MINUTES OF MEETING ON THE BASIC DESIGN  
FOR THE CANCER CENTRE OF THE KINGDOM  
OF SAUDI ARABIA

THE NATIONAL CANCER CENTER ESTABLISHMENT PROJECT IN THE KINGDOM OF SAUDI ARABIA

S U M M A R Y OF THE TECHNICAL REQUESTS  
PROPOSED BY THE SAUDI SIDE

We wish to express our sincerest gratitude for reviewing the presented Draft Basic Design Report I of the National Cancer Center with us and for providing approvals, clarifications and your revisions which are outlined in the attached minutes of meeting and drawings. In cases where difference exists in the contents of minutes of meeting or drawings, the contents of the later minutes of meeting or drawings shall supersede the previous contents.

THE NATIONAL CANCER CENTER  
ESTABLISHMENT PROJECT IN THE KINGDOM OF SAUDI ARABIA  
BASIC DESIGN DRAFT  
JAPAN INTERNATIONAL COOPERATION AGENCY  
REVISED SITE PLAN

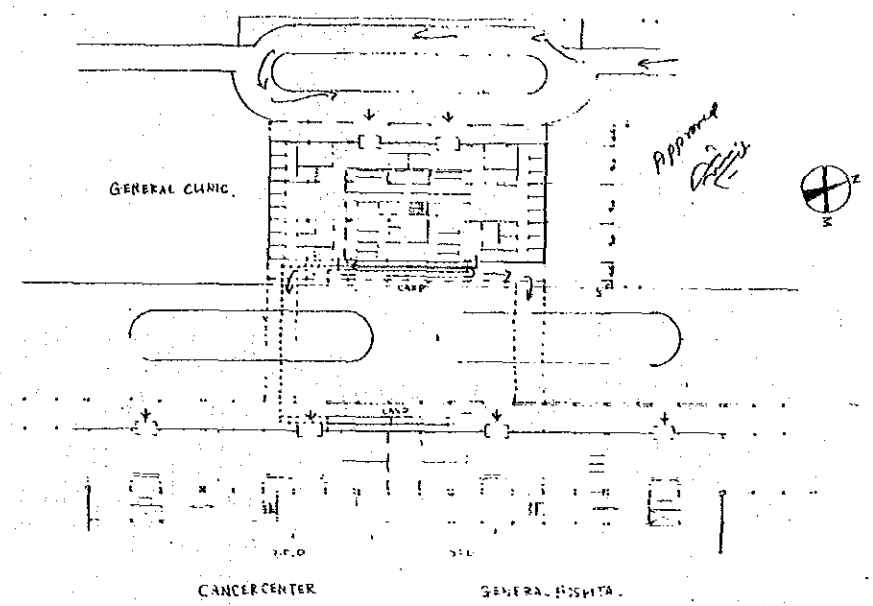
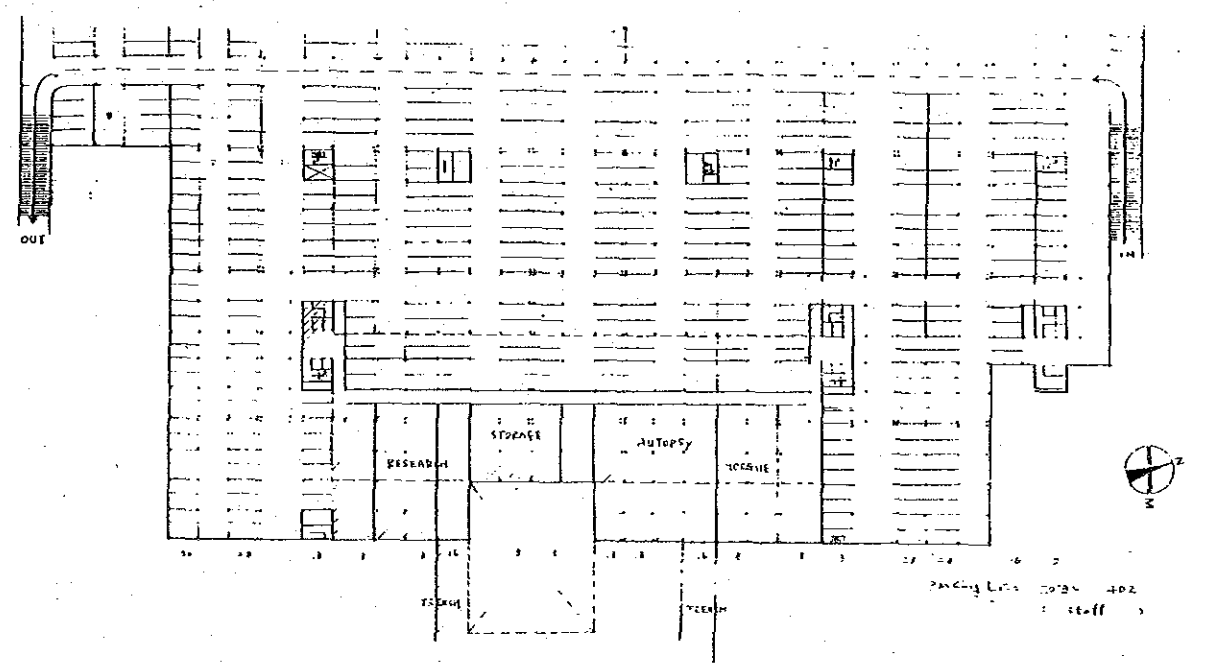
1. Review of the Japanese Study Team's solution on Items Requested at 1st meeting.
  - 1) Site Plan
    - A. Design of access road for the General Clinic as shown in the presented design (revised site plan) was approved. ✓

- B. Plan for replacement of parking facilities and location of additional recreation facilities as shown in Alternative 2 in the presented design (Revised Site Plan) was approved. ✓

1ST. FLOOR PLAN  
18. MAY. '83

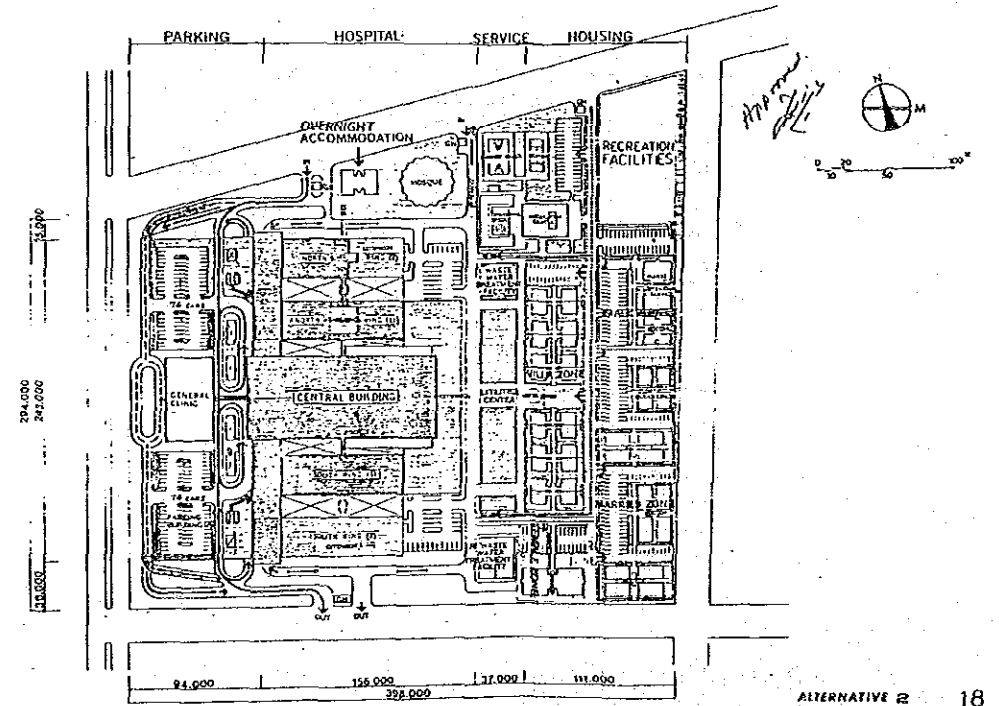
- 2) Floor Plan of General Clinic and Parking facilities.
    - A. Subway pathway was approved as shown in the presented design (1st. Floor plan and Cross section), but 2 subways were requested and the Japanese study team agreed to study the placement of another subway. ✓

BASEMENT FLOOR PLAN  
18. MAY. '83

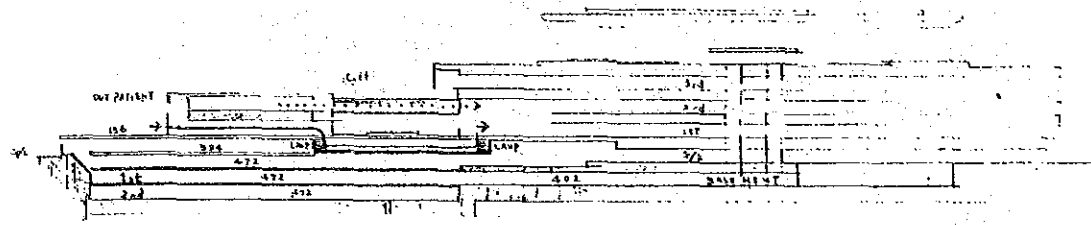
- B. Parking facilities.  
The presented design (Basement Floor Plan and Cross Section) which shows 2 underground stories increased in the Parking building A and parking space in the entire underground of the hospital building instead of increasing 3 underground stories in the Parking Building A was approved. ✓

*Approved*  
*[Signature]*  
**AUDITORIUM PLAN**  
S. 1:300 21 MAY '83

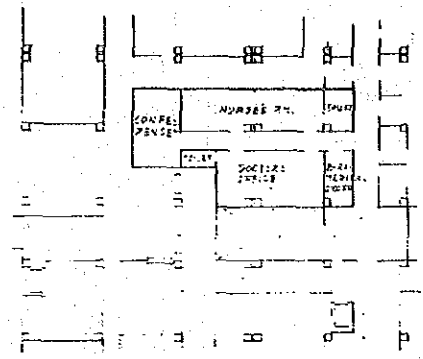
- (1) Auditorium  
Number of seats should be enlarged to accommodate 200-250 from 154. ✓
- (2) Clinical Laboratory.  
Provide a bio-medical instrument work-shop near to the Laboratory. ✓
- (3) Wards, Administration and Blood Bank.  
Approved as shown in the drawing. ✓

- b) General clinic floor plan  
The presented design was approved. ✓
- c) Auditorium enlarged to seat 250 persons.  
The presented design was approved. ✓
- d) Revised design for 3rd floor providing doctors and nurses room in the recovery room which was replaced to each operating theater.  
The presented design was approved. ✓

< JUNIOR NURSES >  
TOTAL UNIT 300 UNITS  
HOUSING PLANS  
25. MAY. '83

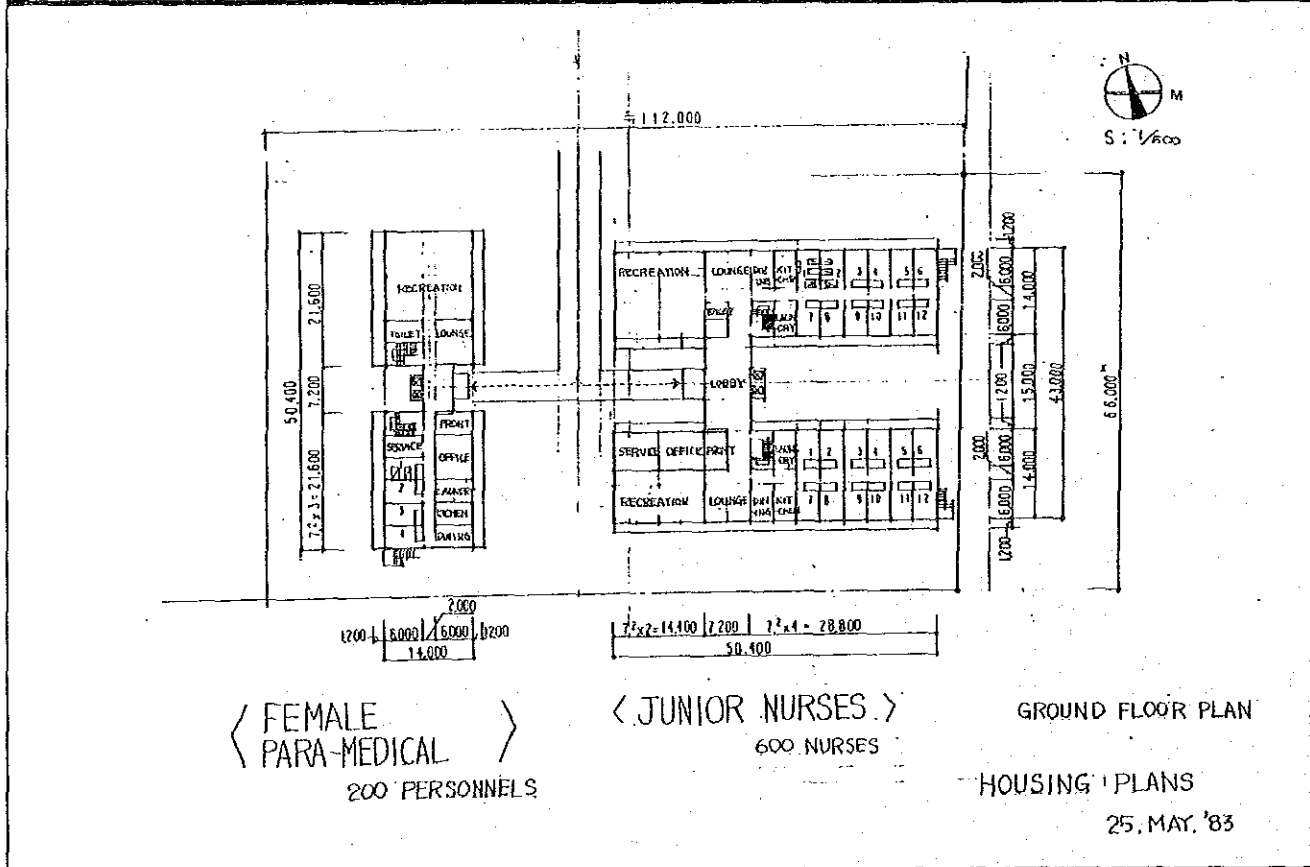
- a) Housing for doctors 130 units and senior nurses 112 units are sufficient. ✓
- b) Housing for 600 junior nurses is necessary, so provide 300 dormitory type rooms with two beds and washing basin for each room. ✓
- c) Housing for 200 female para-medical personnels is necessary. ✓
- d) Provide 4 housing buildings at the former parking building area which was being considered for recreation. 3 buildings are to be dormitory type rooms for nurses and para-medical personnels. Provide toilet, kitchen and living room in the center of each floor, also a recreation room in the basement. Provide about 20 laundry machine with dryer and service facility in the top floor or in the basement. 1 building shall be for small flats consisting of

- a. Approved as shown in drawings.  
Revised site plan, Housing plans for junior nurses and female para-medicals, housing number of units and operating room plans (revised plan B).

## ARRANGEMENT OF CLINICAL DEPARTMENTS FOR O.P.D.

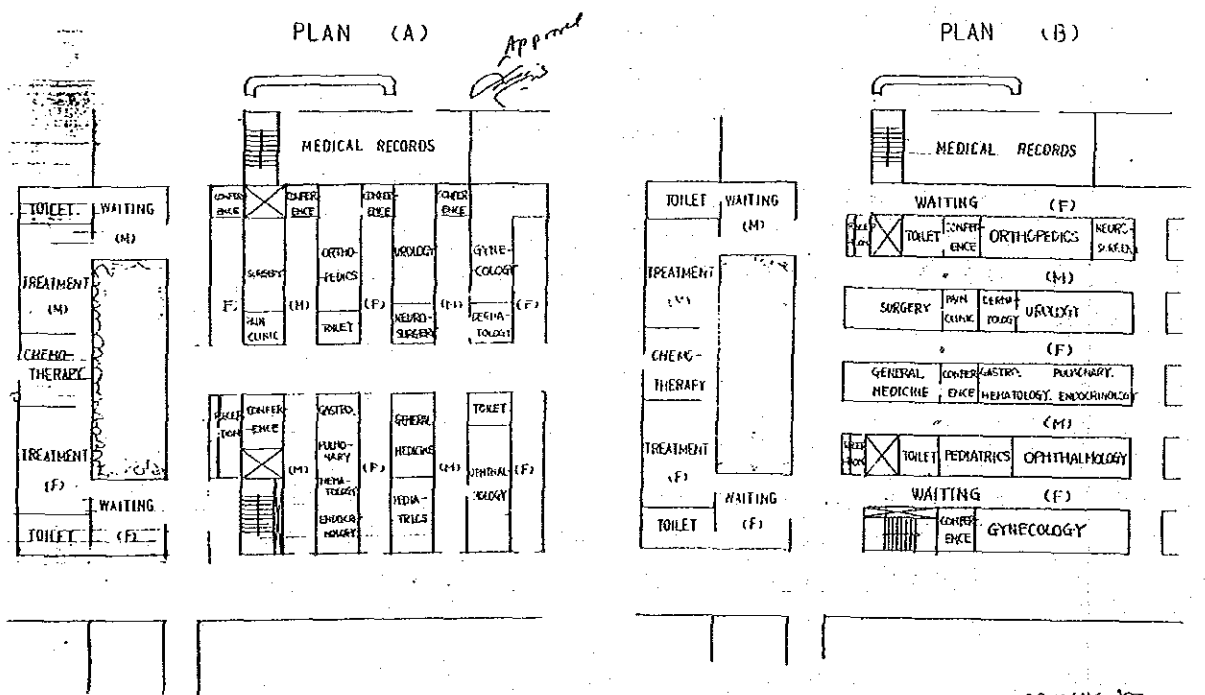
3. Drawings of revised site plan, housing plans for junior nurses and female para-medicals, housing number of units, operating room plans and arranged of clinical departments for O.P.D. were approved as follows :
